**EMERGENCY DROUGHT APPLICATION: GROUNDWATER REVIEW**

TO: Water Rights Section Date: 05/05/2021  
 FROM: Groundwater Section: Michael Thoma  
 Reviewer's Name  
 SUBJECT: Application G- 19106  Re-review; date of original review: ###/###/####

Applicant’s Name: Klamath Basin Research and Extension Center County: Klamath

**Hydrographs for Area Wells**

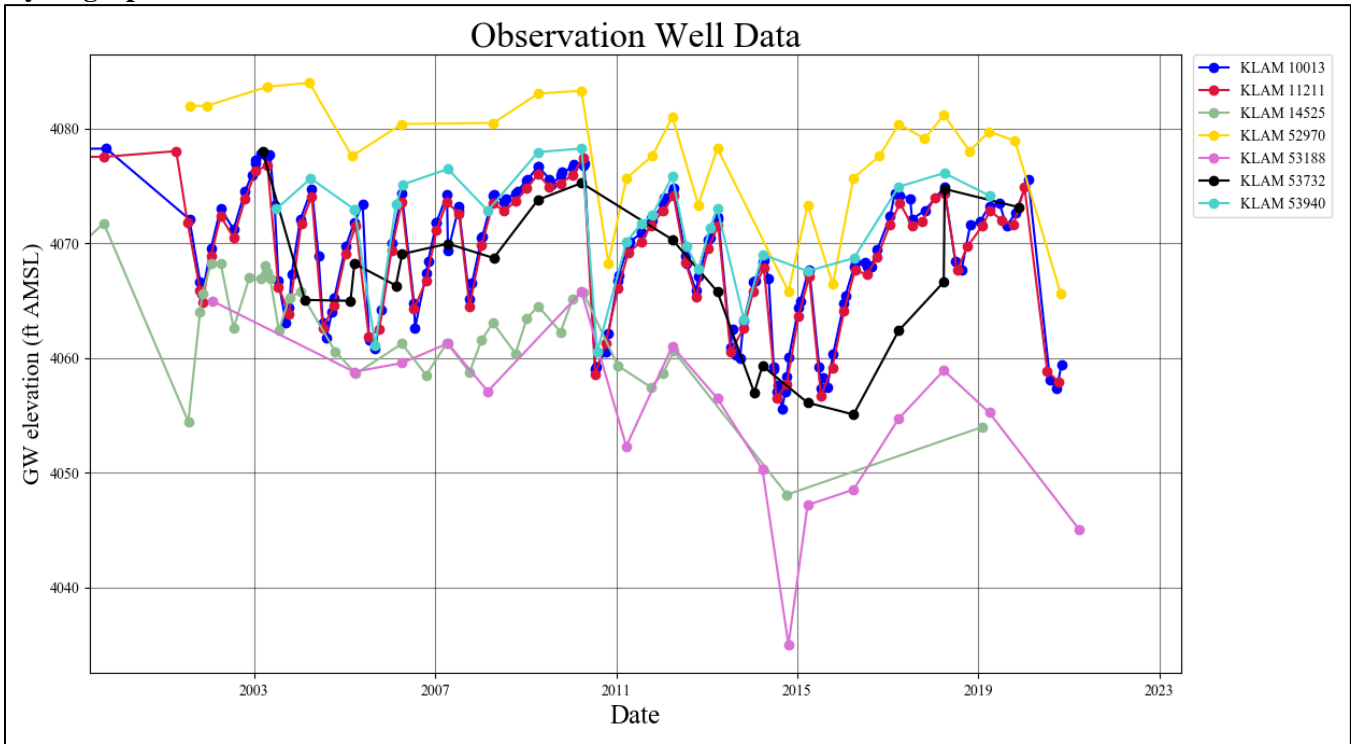
Seasonal groundwater level fluctuations in response to pumping in this area are generally on the order of 10-20 feet and most wells on groundwater rights are deep enough to accommodate this seasonal interference. However, long-term groundwater level declines have been documented throughout the area and are punctuated by drought-related groundwater pumping. Pumping related to 2021 emergency drought use by this, and other wells, is expected to exacerbate these declines, which has the potential to impact shallow wells.
